PEARL BUILDING EAST

LU 16-153002 HRM AD

TYPE III REVIEW SUBMITTAL

APPENDIX C: RESPONSE TO DAR MEMO

NORTH ELEVATION
02. WITH NEIGHBOR EASEMENT AGREEMENT
 1/16" = 1'-0"

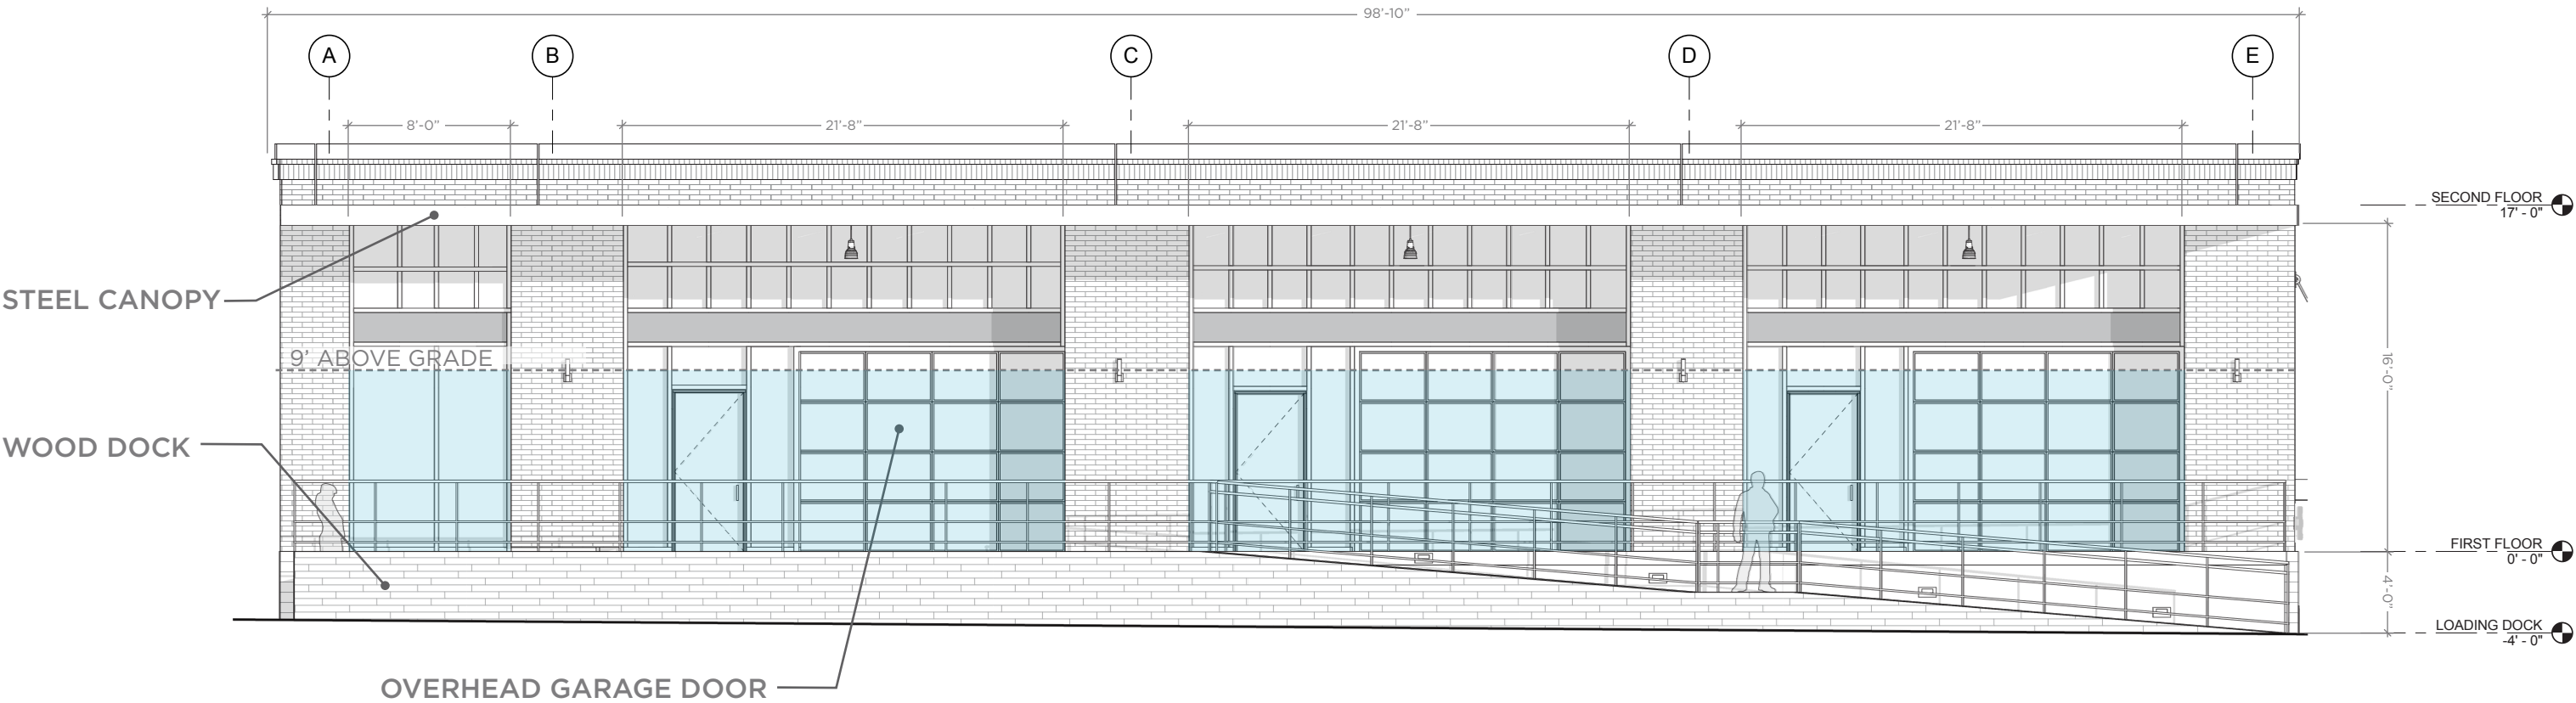
- Pending the outcome of the building appeal and consultation with the northern neighbors facing this elevation, Commission was supportive of windows being added to this elevation, but in either case, decorative brick details such as banding and the cornice should also return this section of the north wall. However, the windows if used should have a simpler appearance at this wall, without inset surrounds.

* If Modern Confectionary Lofts refuses to grant a No-Build Easement, construction techniques will be limited to stacked CMU block with exposed concrete floor slabs and shear core.

RESPONSE: Due to the restrictions posed by property owners to the north, there is a strong possibility that construction techniques will be limited to laid-up CMU from the Project property. Concrete bands would naturally be expressed at floor lines. The Project is submitting one option to add windows in one bay should the neighboring property owners reach a construction agreement.

**ENLARGED GROUND FLOOR SOUTH ELEVATION
(NW GLISAN ST.)**
1/8" = 1'-0"

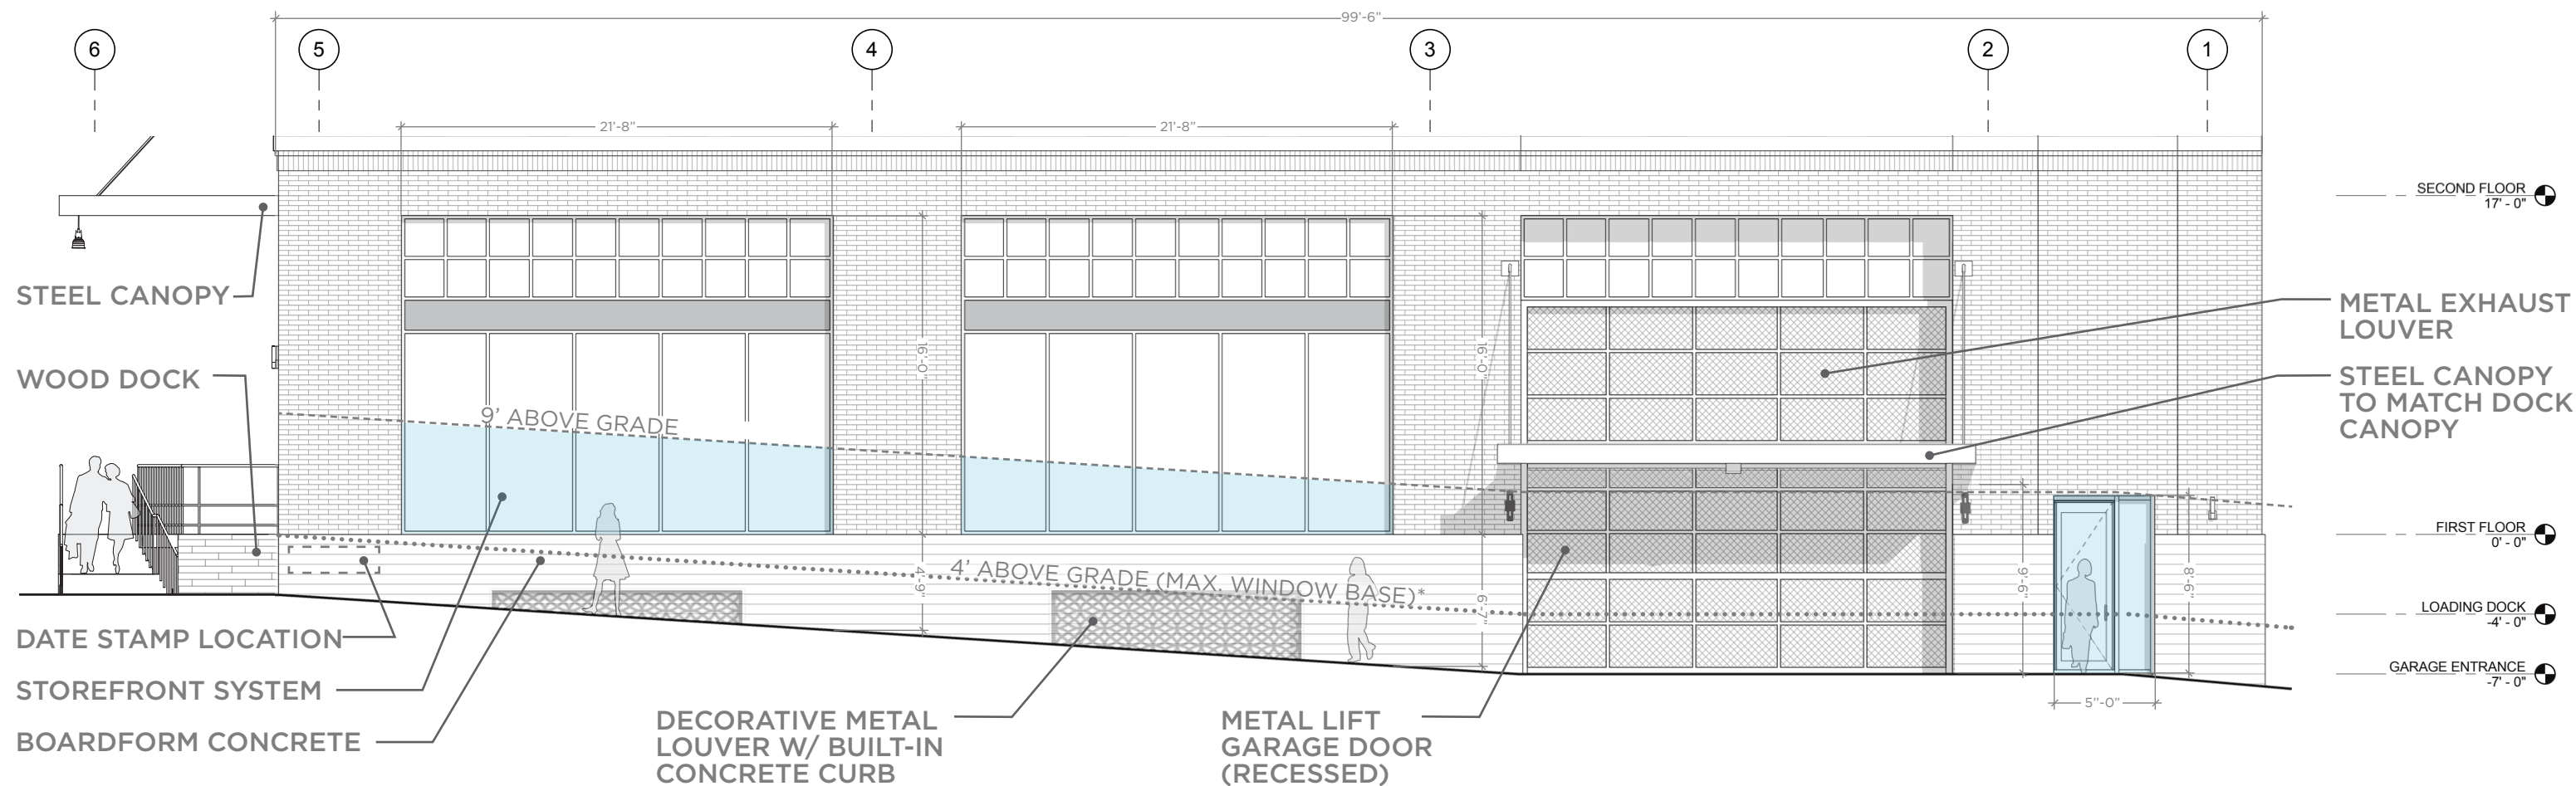
- A. Consider decreasing the scale of the opening at the Glisan Street garage door.
- B. Consider decreasing the scale of the concrete base at Glisan Street.

- A. Project proposes a canopy over the garage entrance to visually break up the scale of the opening, especially at the pedestrian scale.
- B. Project proposes boardform concrete at the base to provide scale and texture. Metal louvers with integrated benches, as seen on neighboring buildings, are also proposed to break scale of the base and enliven the human experience on Glisan Street.

*MODIFICATION REQUEST
(SEE NARRATIVE)

NW Glisan Street Material Options and Precedents

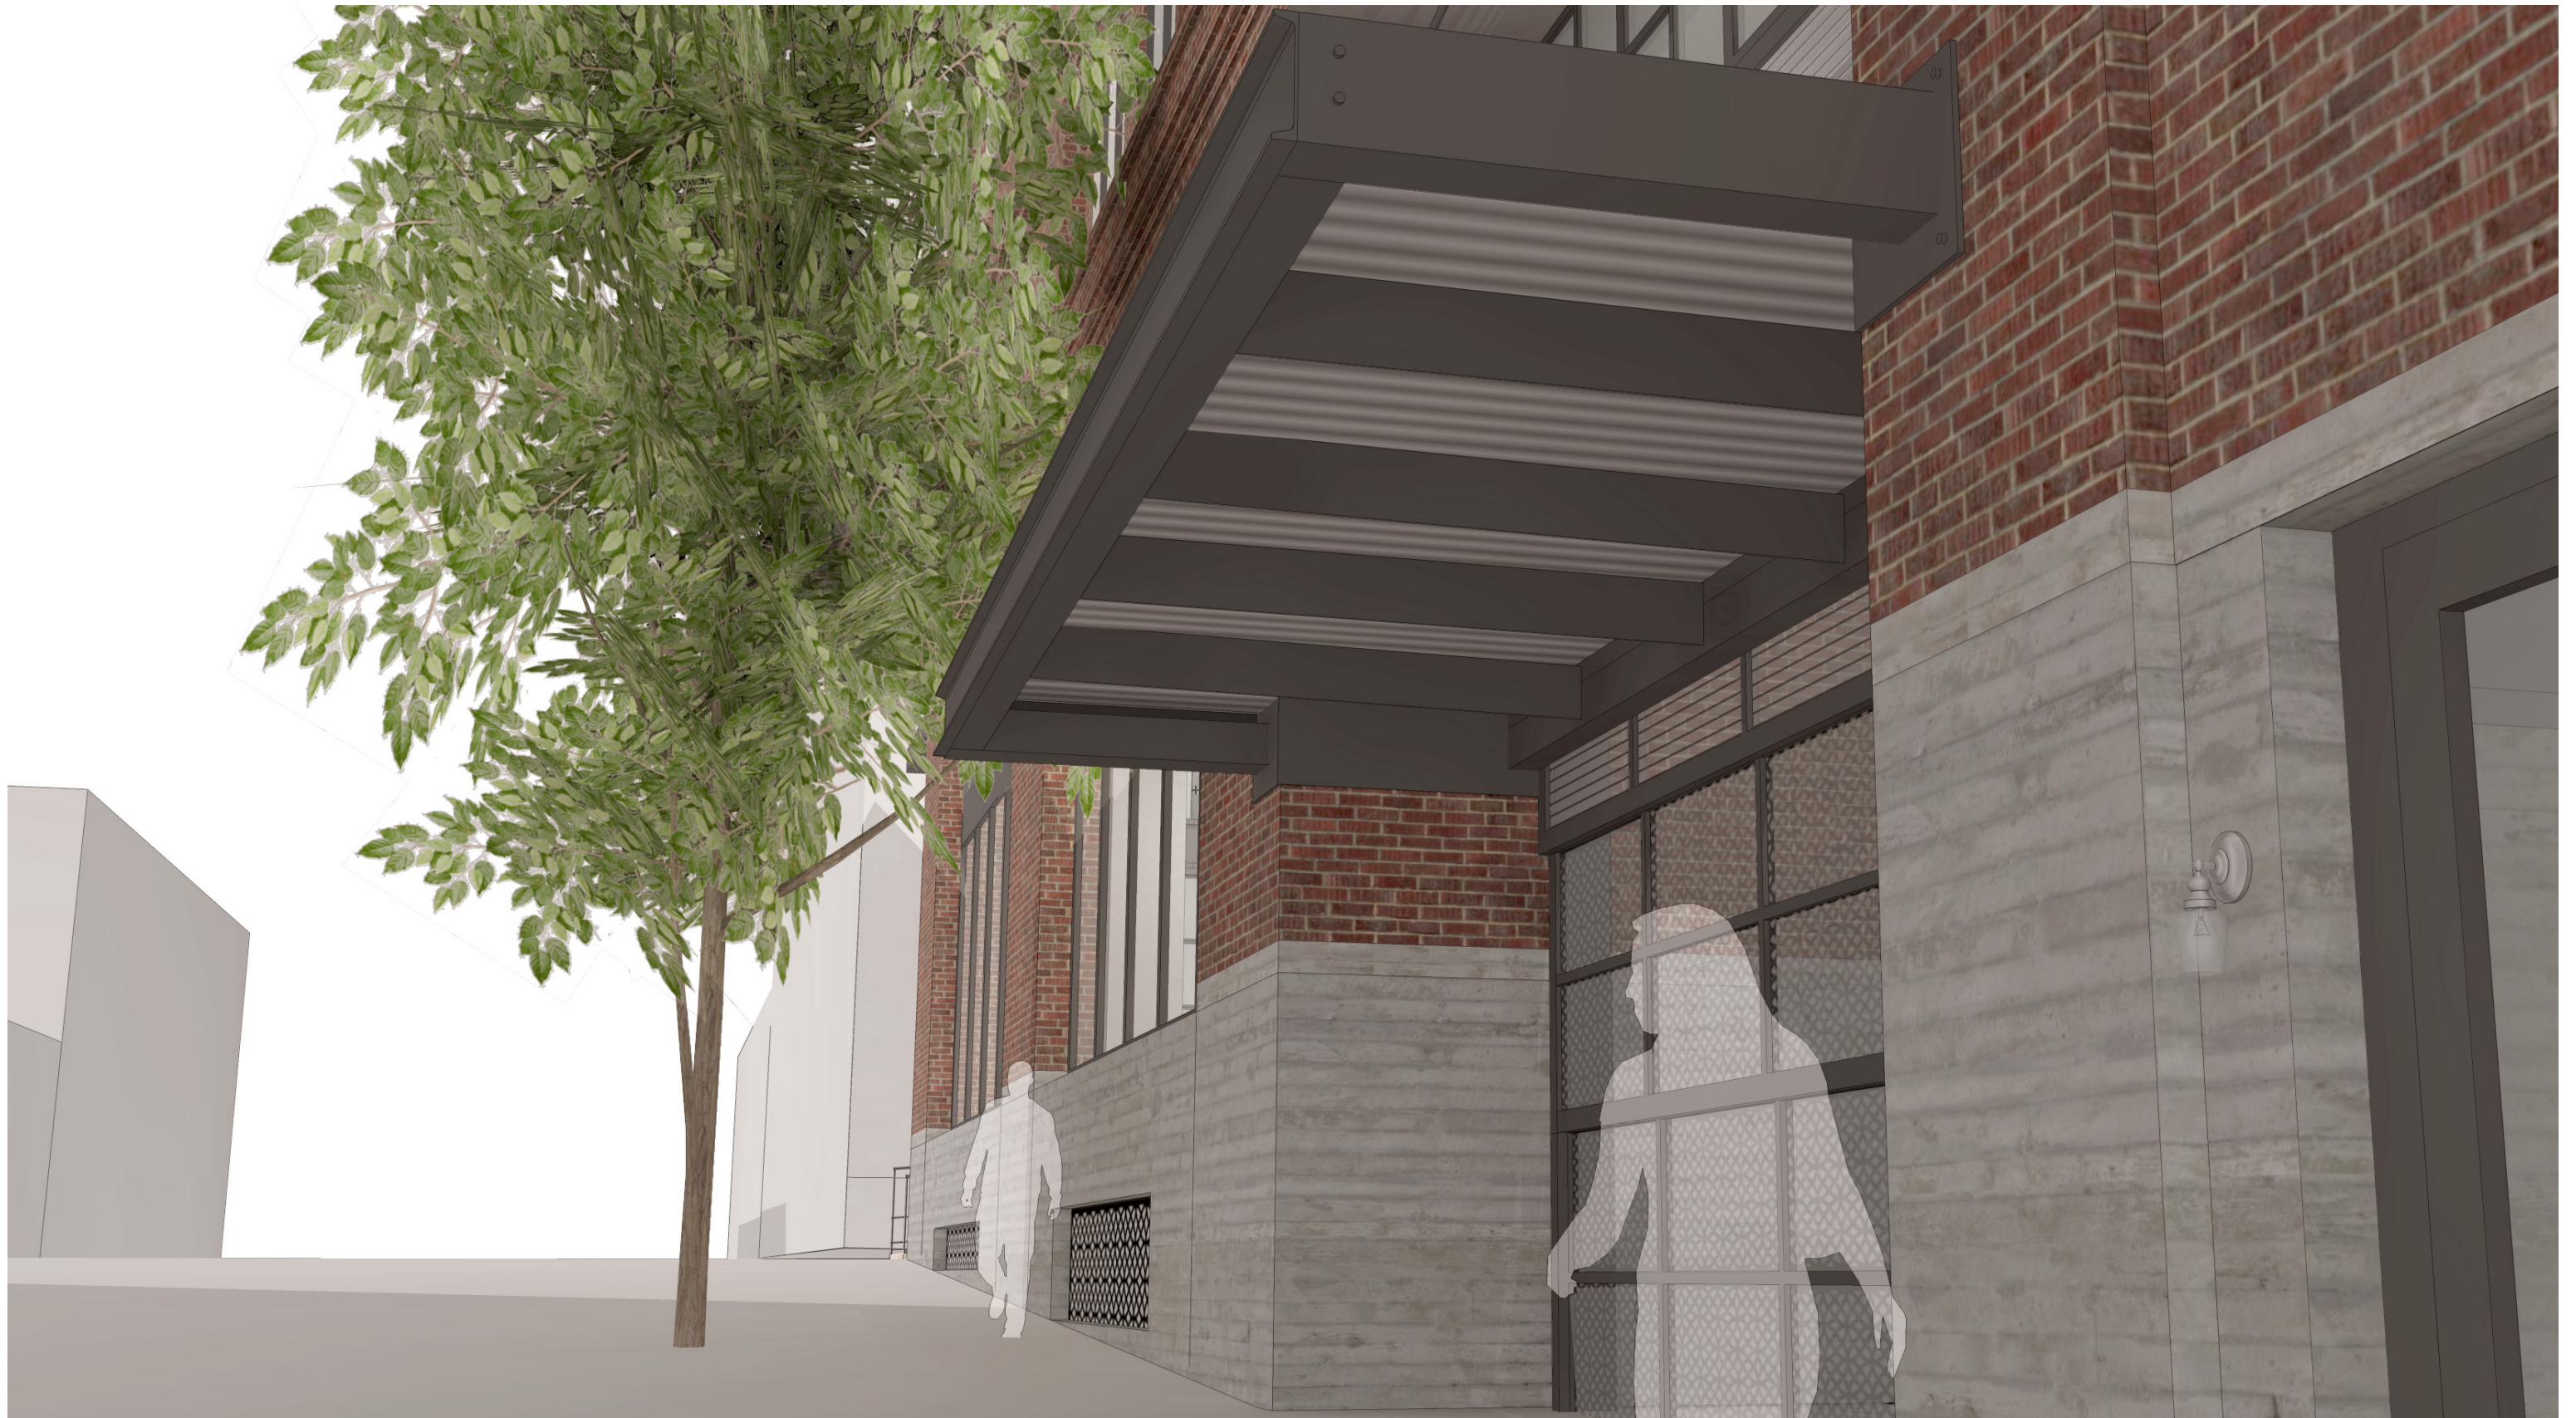
- 1. LOWER AND/OR MITIGATE TALL HEIGHT OF GARAGE DOOR
- 2. REVISE THE GARAGE DOOR AND EXIT DOOR
- 3. BASEMENT LEVEL BELOW THE STOREFRONT WINDOWS NEEDS ADDITIONAL DESIGN REFINEMENT

- 1. RESPONSE:** ADDED CANOPY AT A PEDESTRIAN SCALE TO BREAK UP PLANE OF OPENING. GARAGE DOOR AND LOUVERS SET BACK FOUR FEET TO CREATE ADDITIONAL DEPTH IN THE FACADE.
- 2. RESPONSE:** ADJUSTED PATTERNING AND SEGMENTATION OF GARAGE DOOR AND LOUVERS. REMOVED WINDOW AND TRANSOM ABOVE EXIT DOOR TO ESTABLISH HIERARCHY.
- 3. RESPONSE:** ADDED DECORATIVE LOUVERS BELOW RETAIL WINDOWS TO BREAK UP CONCRETE BASE.
